# Baseline CRU Implementation Text for FECo and FECi PMDs

**IEEE P802.3dj Plenary Meeting**

**March 11, 2024**

Figure 121-4—TDECQ conformance test block diagram

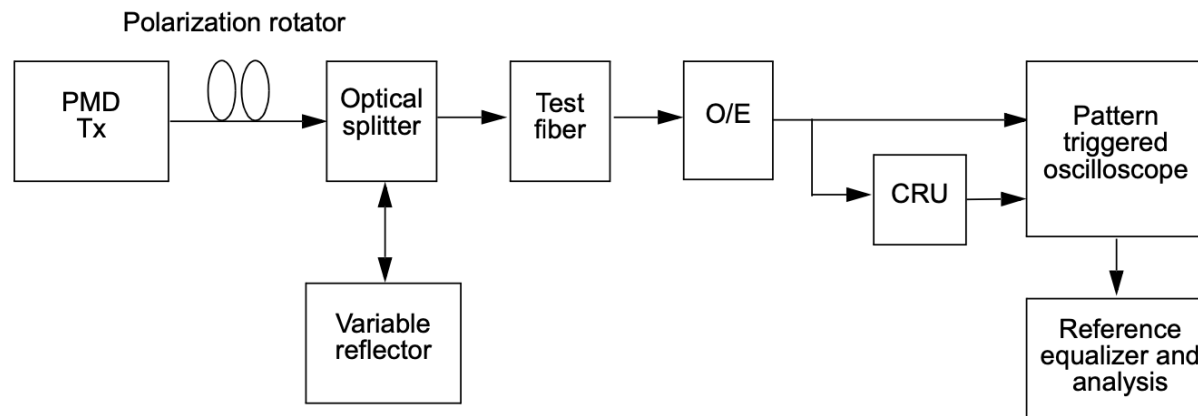
- Add “The clock recovery unit (CRU) has a corner frequency of 4 MHz and a slope of 20 dB/decade. The CRU can be implemented in hardware or software depending on oscilloscope technology” to TDECQ and TECQ definition 180.9.5/180.9.6 and 181.9.5/181.9.6
- Also add following figure, but after polarization rotator add two more loops to indicate fiber for TDECQ measurement. For TECQ refer to the same figure but measured without fiber.

Figure 121-4—TDECQ conformance test block diagram

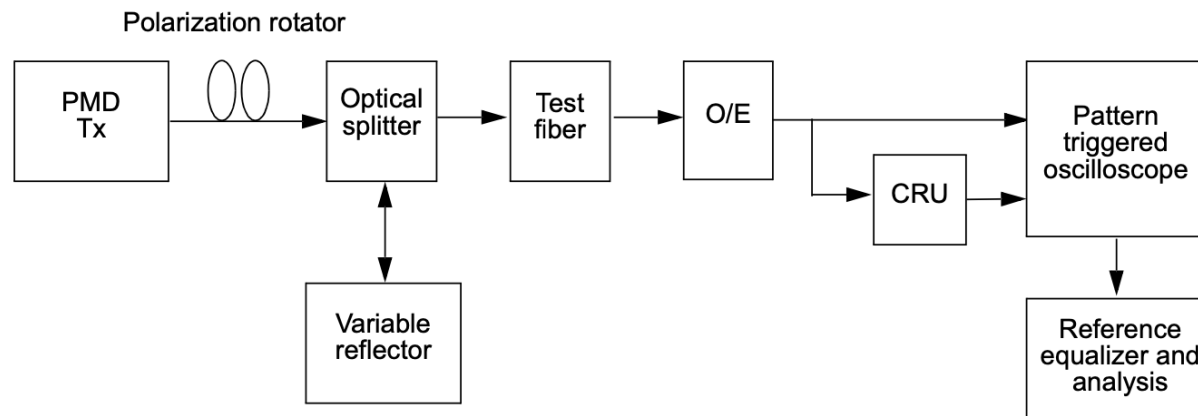
- ❑ Add “The clock recovery unit (CRU) has a corner frequency of 4 MHz and a slope of 20 dB/decade. The CRU can be implemented in hardware or software depending on oscilloscope technology” to TDECQ and TECQ definition 182.9.5/182.9.6 and 183.9.5/183.9.6
- ❑ Also add following figure, but after polarization rotator add two more loops to indicate fiber for TDECQ measurement. For TECQ refer to the same figure but measured without fiber.
